**SUSQUEHANNA STEAM ELECTRIC STATION  
PROPOSED AMENDMENT NO. 282 TO  
FACILITY OPERATING LICENSE NPF-14:  
PROPOSED CHANGE TO TECHNICAL SPECIFICATION 2.1.1.2  
MCPR SAFETY LIMIT  
PLA-5967**

**Docket No. 50-387**

**PPL SUSQUEHANNA EVALUATION OF  
PROPOSED CHANGE TO  
UNIT 1  
TECHNICAL SPECIFICATION 2.1.1.2**

# SUSQUEHANNA UNIT 1 CYCLE 14 MID-CYCLE REDESIGN PROPOSED CORE LOADING PATTERN

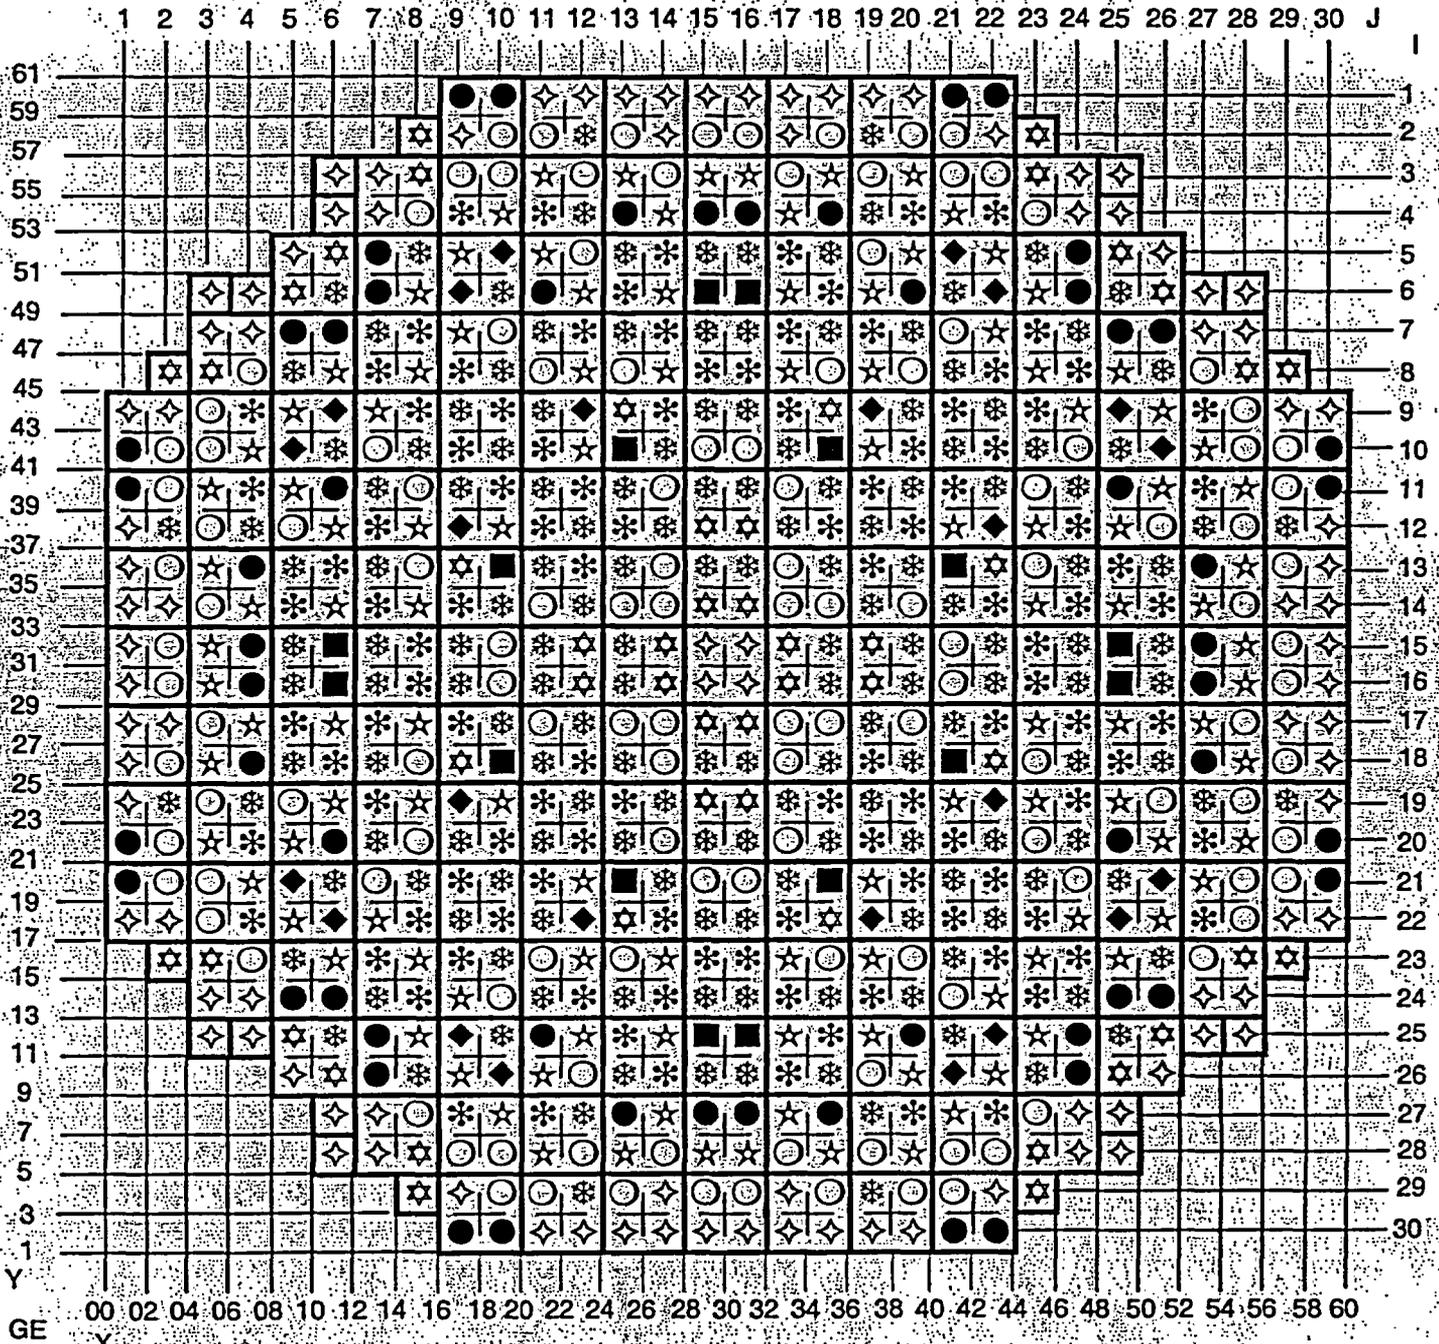
The core loading pattern changes for the mid-cycle outage are designed to mitigate control cell friction while maintaining U1C14 reactivity and depletion characteristics (to the extent possible) to minimize impacts/changes to the current COLR limits. The core re-design will rechannel up to 77 fuel assemblies. In addition, 56 fuel assemblies will be discharged. The 56 fuel assemblies are split as follows: 32 fuel assemblies initially loaded in Unit 1 Cycle 13, and 24 fuel assemblies initially loaded in Unit 1 Cycle 12. The 56 fuel assemblies will be replaced with fuel assemblies initially loaded in Unit 1 Cycle 12 and discharged following Unit 1 Cycle 13. The proposed revised core loading pattern is provided as Attachment 2. The corresponding core composition is:
